ATTACHMENT I

PROPOSED TECHNICAL SPECIFICATION

MANAGEMENT TITLE CHANGES

POWER AUTHORITY OF THE STATE OF NEW YORK
INDIAN POINT 3 NUCLEAR POWER PLANT
DOCKET NO. 50-286

FIGURE 6.2-1

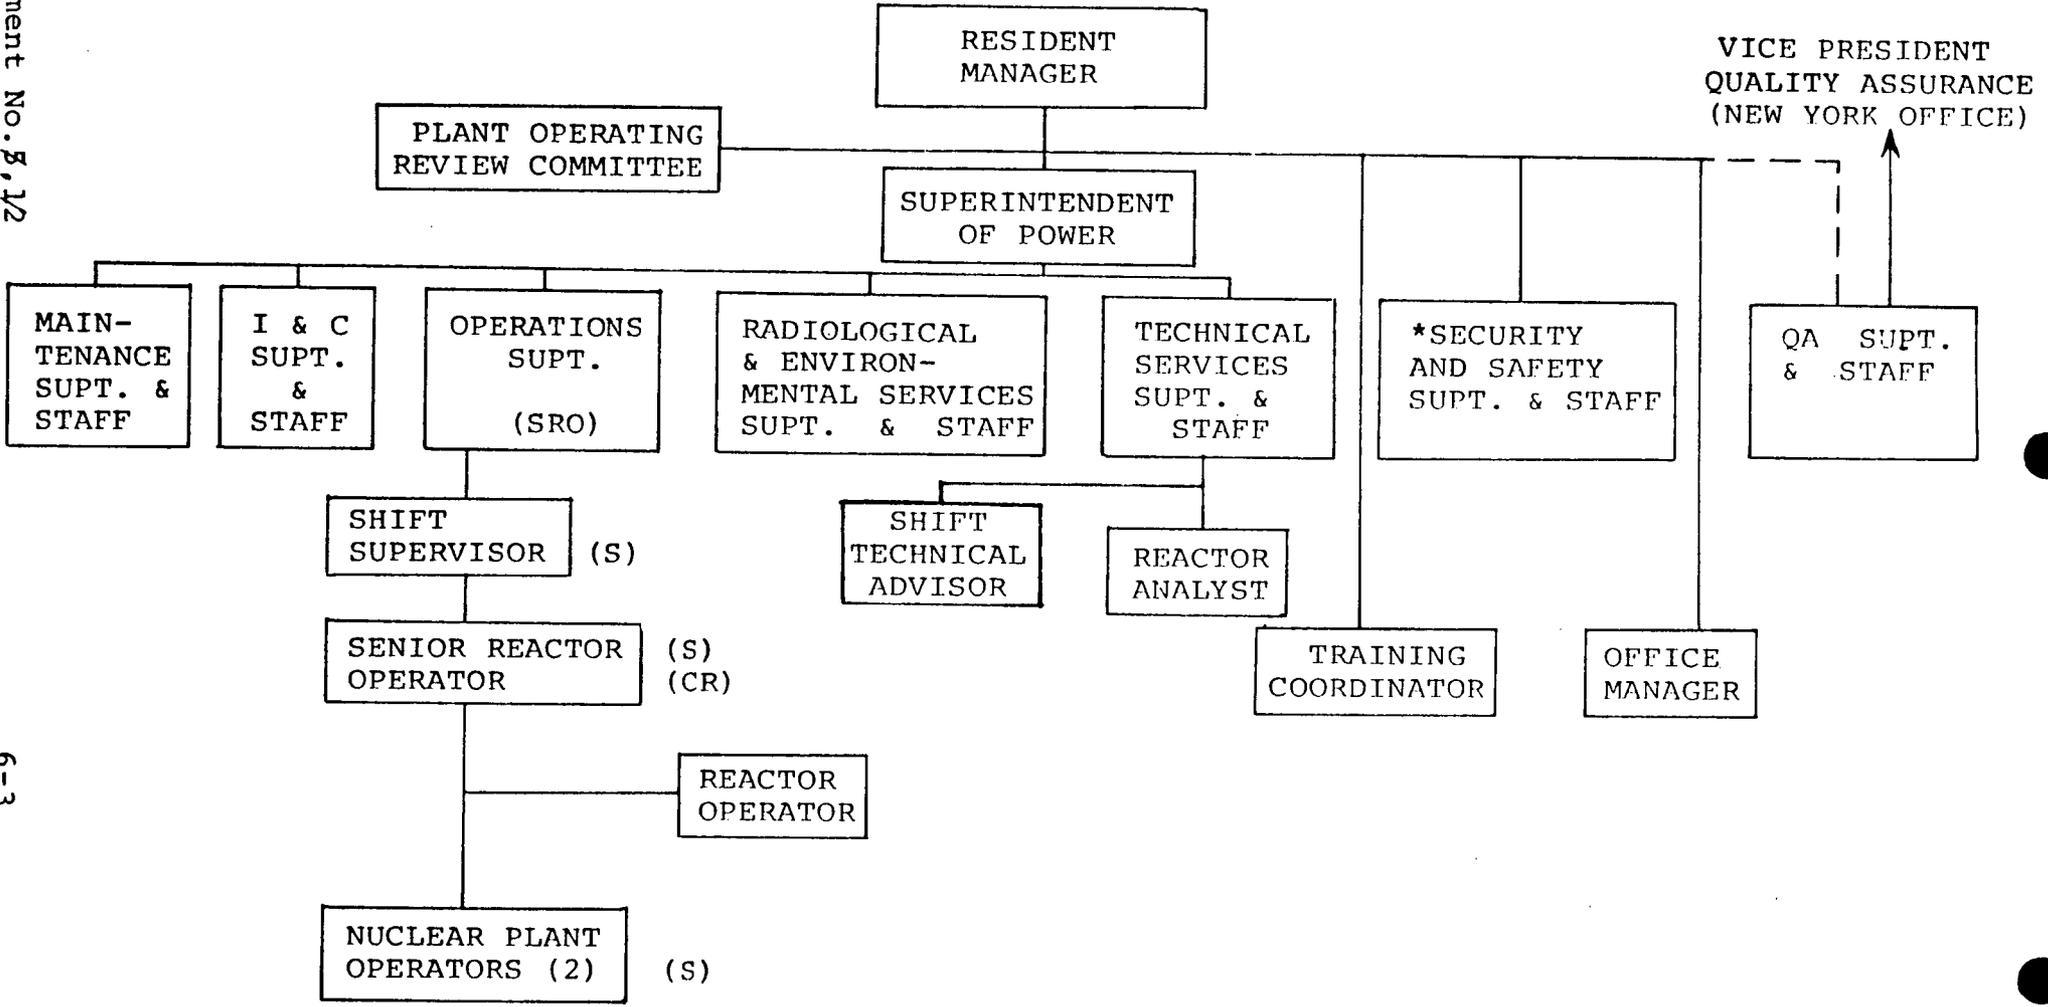
6.1.1 The Resident Manager shall be responsible for overall facility operation. During periods when the Resident Manager is unavailable, the Superintendent of Power will assume his responsibilities. In the event both are unavailable, the Resident Manager may delegate this responsibility to other qualified supervisory personnel. The Resident Manager reports directly to the Sr. Vice President Nuclear Generation, as shown in Fig. 6.2-1.

6.2.1 The offsite organization for plant management and technical support shall be as shown on Figure 6.2-1.
